13. PUBLIC HEARING / QUASI-JUDICIAL. 575 Los Trancos [21PLN-00196]: Adoption of a Record of Land Use Action Approving a Major Site and Design Application for the Construction of a new 7,245 Square Foot Single-Family Residence With a new 895 Square Foot Accessory Dwelling Unit and Associated Site Improvements, on a 5.38-Acre Site. Zoning District: Open Space (OS). Environmental Review: Adoption of a Mitigated Negative Declaration and Mitigation Monitoring and Reporting Program. *Title Updated, Public Comments, Presentation* (8:30 – 9:30 PM)

CITY COUNCIL STAFF REPORT

PUBLIC HEARING / QUASI-JUDICIAL. 575 Los Trancos [21PLN-00196]: Major Site and Design Application for the Construction of a new 7,245 Square Foot Single-Family Residence With a new 895 Square Foot Accessory Dwelling Unit and Associated Site Improvements, Including a Swimming Pool, on a 5.38-Acre Site. Zoning District: Open Space (OS). Environmental Assessment: A Draft Mitigated Negative Declaration was Circulated for Public Comment on August 17, 2022 and Ended on September 16, 2022.

Creek to House Diagram

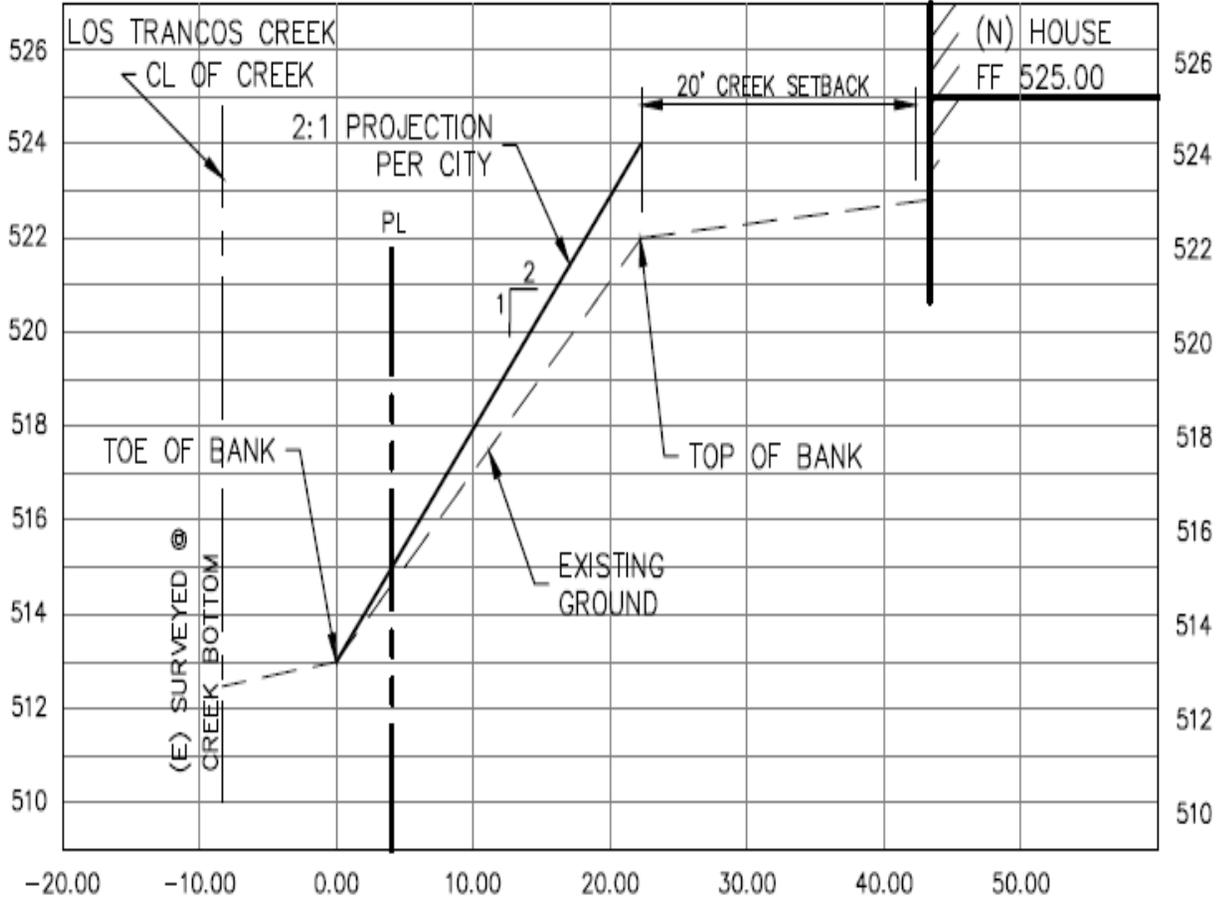
Setback from the Creek

- The Zoning Ordinance requires a 20 foot setback from the top-of-bank.
- The Comprehensive Plan includes a policy to “explore” a 150 foot setback from streams and conditions for a reduced setback for single family residences.
- This policy has not been implemented in the zoning code.
